Expert Witness Report

Planning Scheme Amendment – City of Greater C387ggee

Date: Friday 29 September 2023

This report forms a review of the Jetty Road Urban Growth Plan (JRUGP) and associated drainage matters. Specifically:

Figure 1. Jetty Road Stg1 DCP (2011)

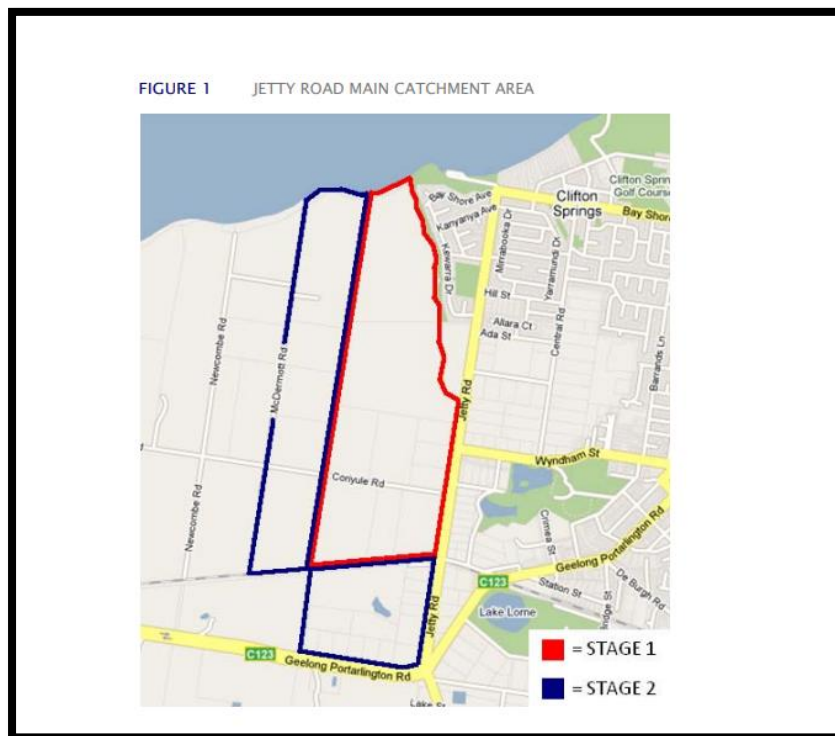
In my opinion the external drainage projects should have been considered in the Stage 1 SWMP. The catchments were identified, the terrain was described as undulating and requiring a piping solution, and the volume and frequency change potential was outlined in the JRGUP. There is no defined waterway to discharge too, and the development would be highly likely to cause a detrimental effect to downstream landholders despite the proposed basin systems.

Figure 3. Endorsed Development Plan (iii) Catchment and SWMP

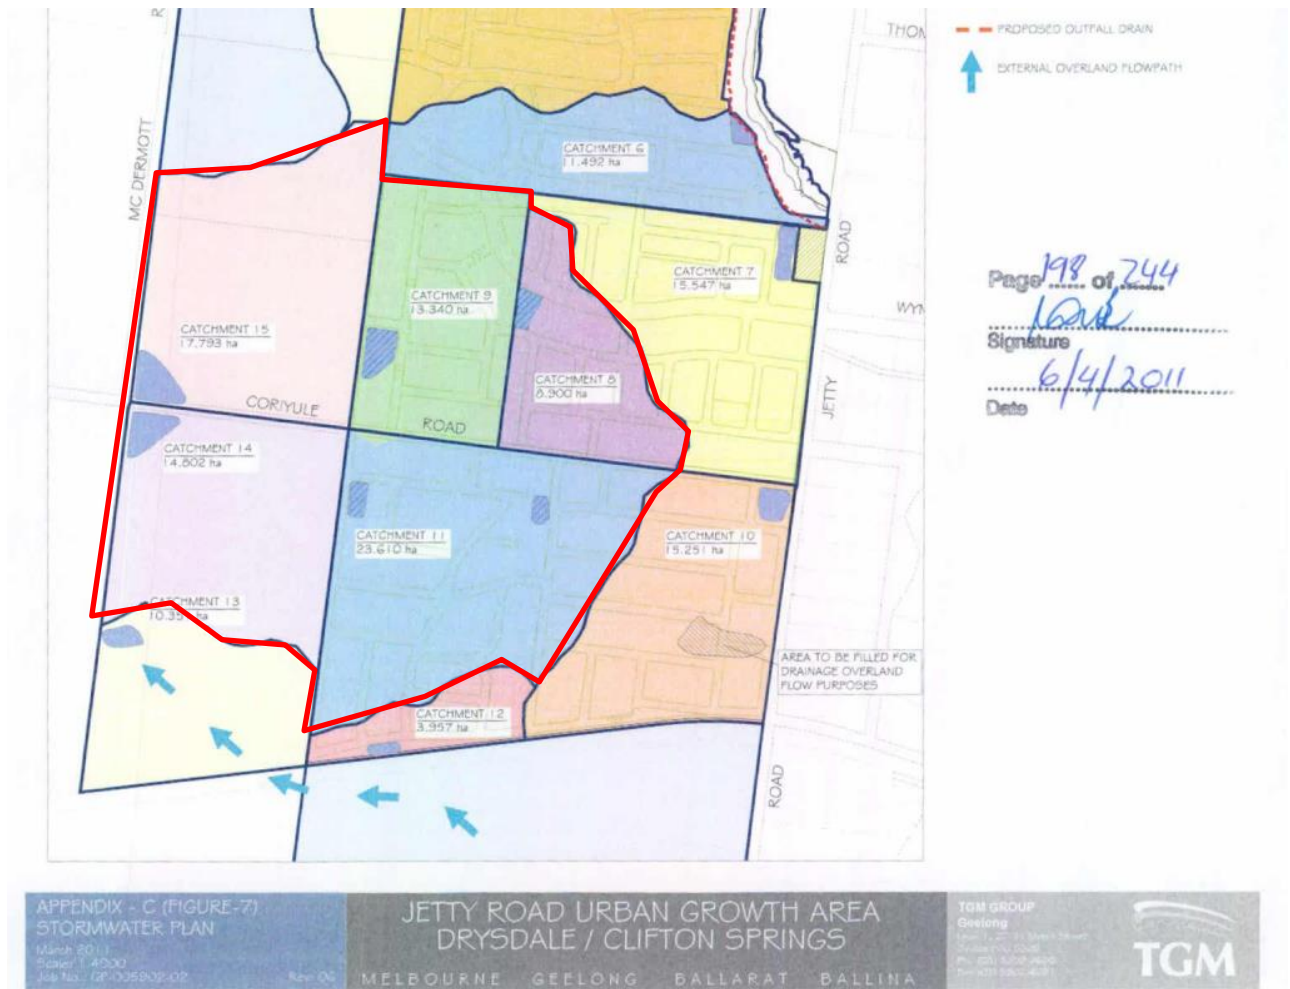
the JRUGP were considered in the SWMP. The catchment plan contained in this document can be seen in Figure 3, with the catchments of interest highlighted.

The TGM SWMP does not provide any calculations as to the expected flows from the catchments (pre or post development) but does quote that the following was used in the formulation of basin requirements:

- Noted they used an Adam's method formulation for pre-development flows Time of Concentration calculation.
- Noted that they used a Runoff Coefficient of 0.33 for the pre-development Q_{100} flows.

- Have not stated what other timing assumptions are used for post-development flows (TC method, slope assumptions, Runoff Coefficients)
- Have only stated the 100y ARI calculations, it is unclear if the 5y and 1.5y ARIs were considered as per the JRUGP objective.

- The report does state that the 3 month, 5y and 100y flows should be matched for discharges to Griggs Creek but does not show how this is achieved or if this is applied to other outfalls.

- There is a suggestion that the wetlands will attenuate the 3 months storm, and that if the 100y storm volume is calculated the more frequent storms can also be attenuated in this volume. No calculations have been provided to show this, though this is logically possible.

To check the basic sizing within the SWMP against industry ratios the stated areas have been reverse engineered from the reported assumptions, and the listed volumes in the report and are shown in 0. Generally, across Victoria an expected volume to hectares ratio for residential development should be anywhere between 300-600 m^3/ha dependent on rainfall band and development intensity. The nominated density in the JRUGP is 14 lots/ha minimum. These rates without any further information or detail would seem on the low side of contemporary understandings.

Contemporary water quality sizing for a wetland system is around 3-4% depending on rainfall banding, EDD selection and catchment density. Again, the shown rates would seem on the low side, but given the calculation age (2011) these rates may have been possible (newer standards are more prescriptive and as such require more land).

Figure 7. Undulations in Coriyule Road pipe alignment (COGG, 2015)

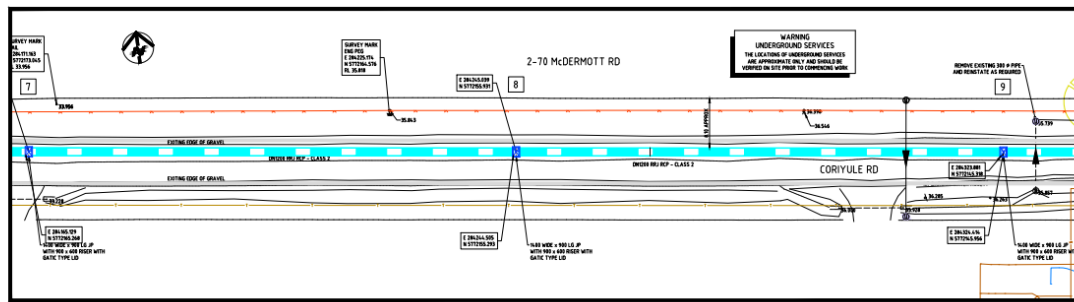
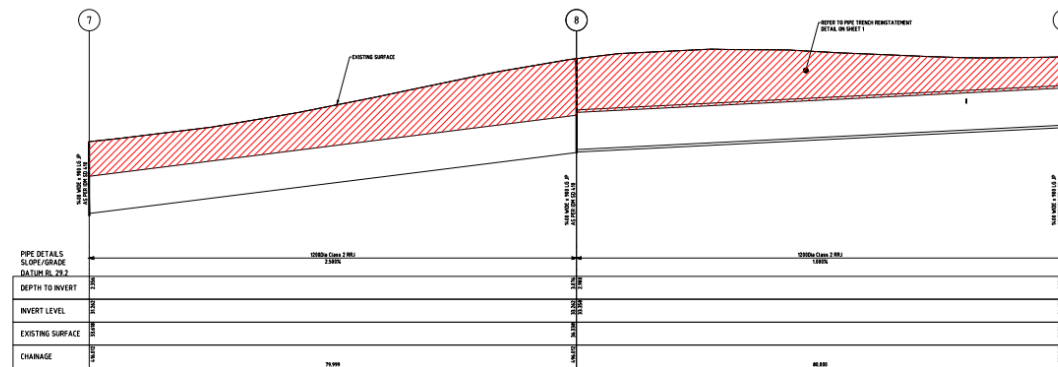
The terrain for the area is well described by the above paragraph as can be seen below (Figure 6, Figure 7).

Based on these descriptions, the stated JRUGP objectives, terrain analysis, and resulting pipe alignments it would be hard to argue that a piped solution to the outfall would not be required for Stage 1 works from these catchments.

Figure 8. Stage 2 Western Outfalls

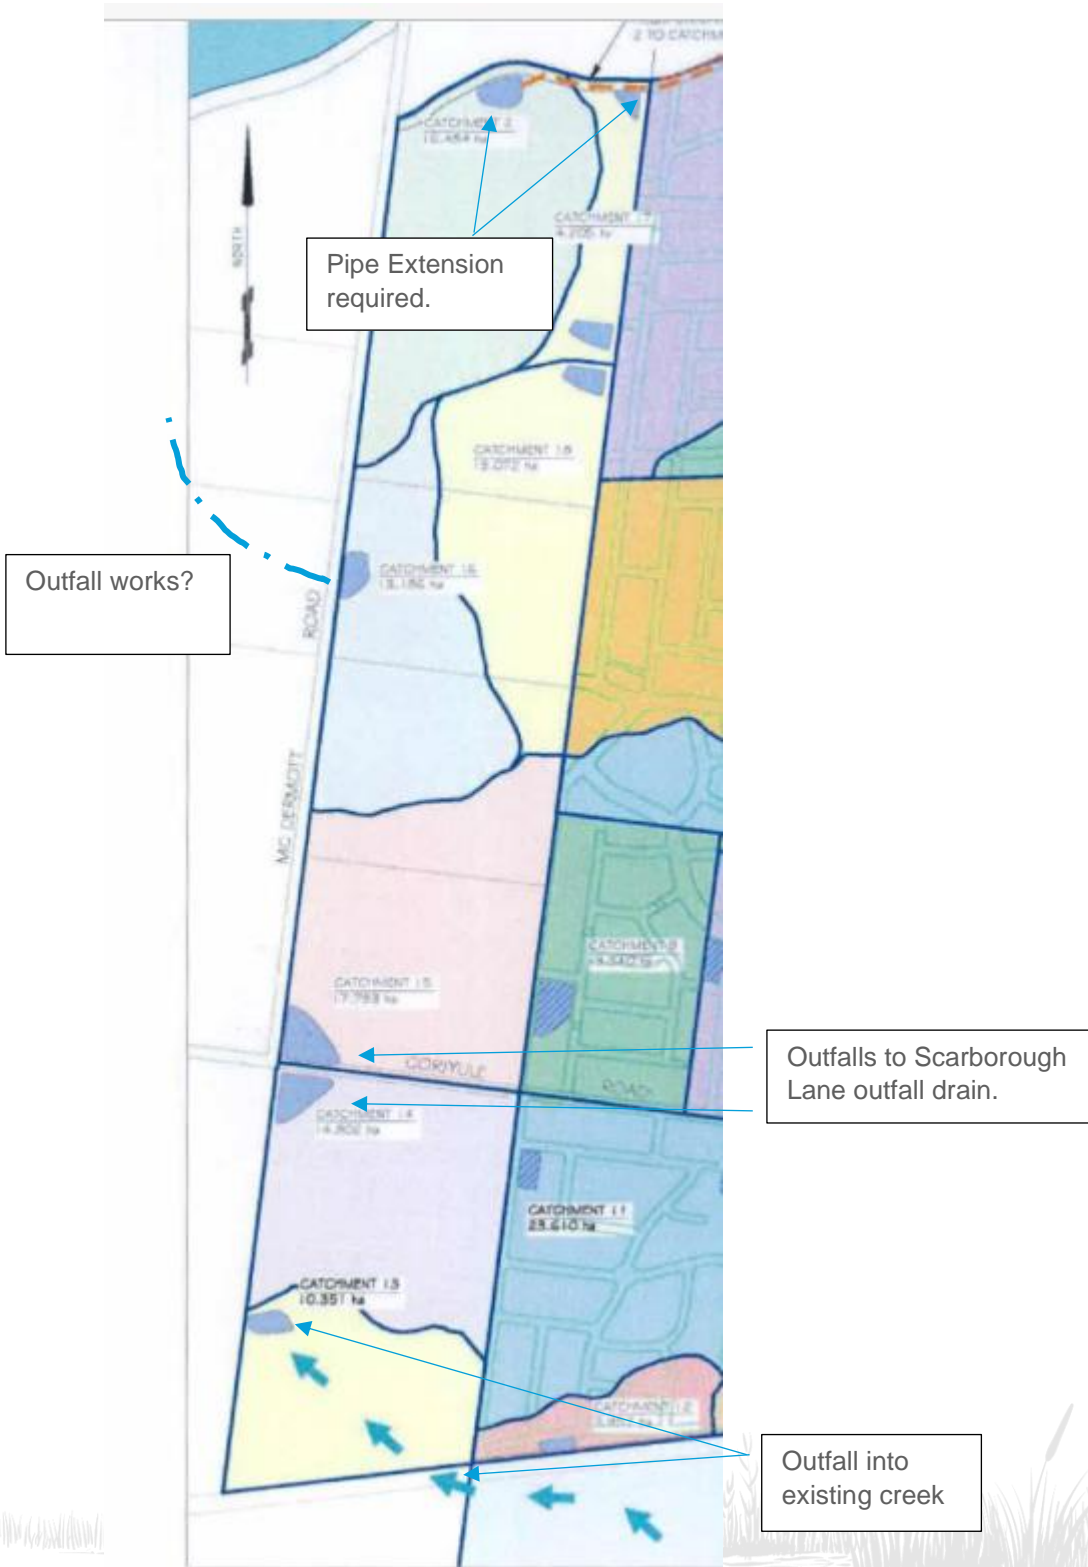
As highlighted in the TGM (2011) report at least 4 outfalls are required for the Western Areas. These are highlighted in Figure 8, but can be cross referenced somewhat with Figure 6 above. Consideration of these outfall requirements should be made in conjunction with the Stage 2 DCP works. Specifically:

- Northern outfall - an extension of the outfall drain provided for property 1 as shown in the SWMP is required to drain properties 11 and 12 and parts of property 13. Given that this piece of infrastructure benefits multiple properties it would generally be considered a DCP item unless developer agreement can be sought. Similarly, the outfall wetlands for these properties could be combined for better efficiency.

- Midpoint outfall - The currently proposed midpoint outfall is to a local low point on McDermott Rd. There is not however a discernible flow path past the existing dam on McDermott Rd, and as such any change in volume or frequency will be experienced acutely. As such, without further outfall works (pipe or easement to waterway) there is likely to be concerns with this approach. An alternative is to pipe (as a minimum low flow) to the northern outfall with storages to limit the flow

rate to the defined pipe capacity. This approach would further the argument for the northern outfall extension (properties 11,12,13 connection) to become a DCP item. This issue is highlighted in Figure 8 and Figure 9. These points are also considered in the WT, June 2022 document.

Figure 15. Jetty Road Infrastructure Plan

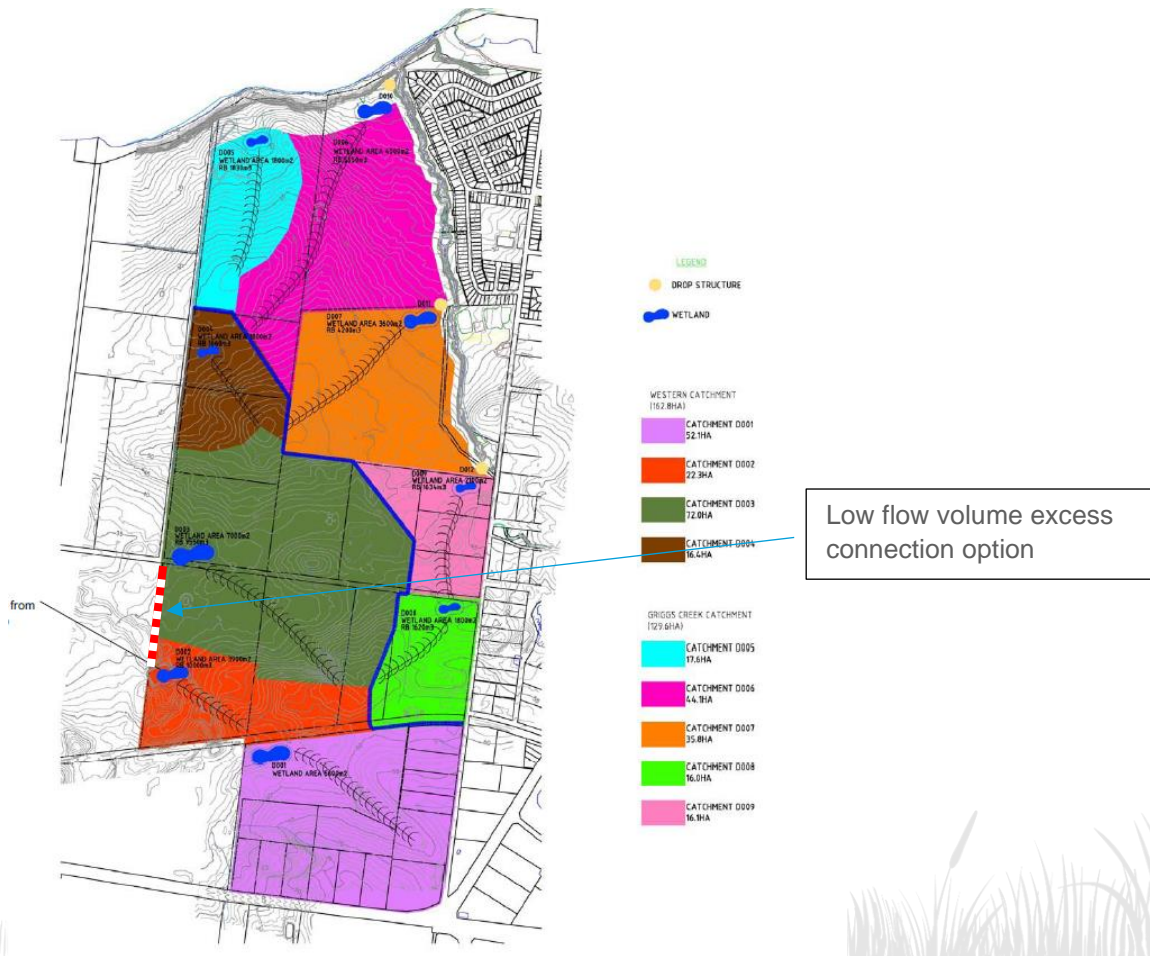
Whilst these options and values have not been cross checked; they are in the general order of magnitude of options I have tested in similar projects. As such it would seem that the Ocean Outfall connection is the most viable of these options. To meet the performance objective a low flow pipe for the area would be required, with the most efficient location on property 15 as shown in Figure 15.

Given the number of properties addressed by this pipe it is suggested that this would be a Stage 2 DCP item. This in turn would require all of the properties 15 through 30 to contribute to the Scarborough Road outfall drain as constructed in Stage 1 (Orange and Magenta areas as shown).
